RECALL CAMPAIGN BULLETIN

NTB08-003

**VOLUNTARY EMISSIONS RECALL CAMPAIGN
2008 PATHFINDER V-8 EMISSION LABEL****CAMPAIGN I.D. #** R0714**APPLIED VEHICLE:** 2008 Pathfinder (R51) with V-8 engine**APPLIED VINs:** 5N1BR18**8C 600000 - 644269**INTRODUCTION**

Figure 1

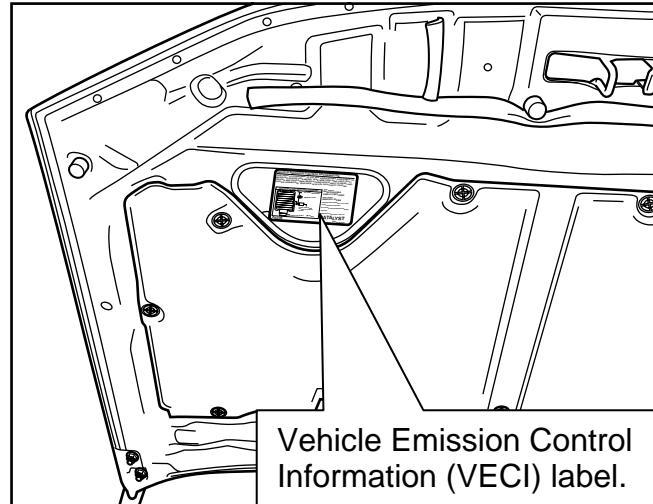
5. Locate the existing under-hood VECI label.
6. Clean the label and the area around it with a mild detergent and water.

- Care should be taken not to use harsh chemicals that may damage the existing label.
- It is important the surface be free of dirt and oil to ensure proper adhesion of the new label.

Figure 2

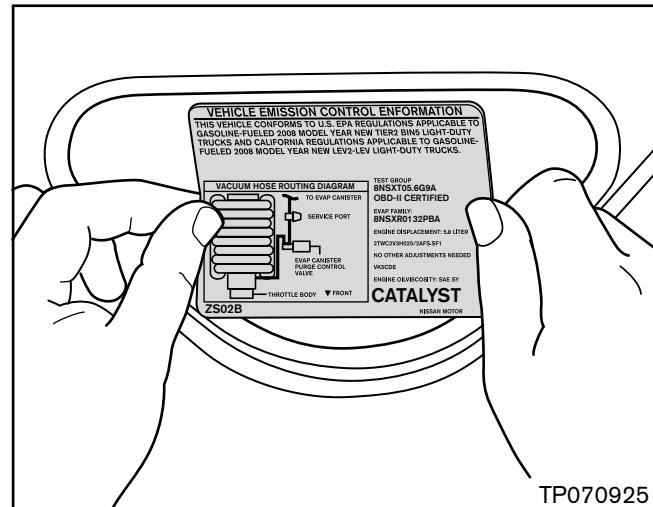
7. Completely dry the label and the area around it.
8. Peel the new label from the backing sheet and install it directly over the top of the existing label.

NOTE: The adhesive on the label is permanent. Extra care should be taken when applying the new label since it can not be moved once it is attached.
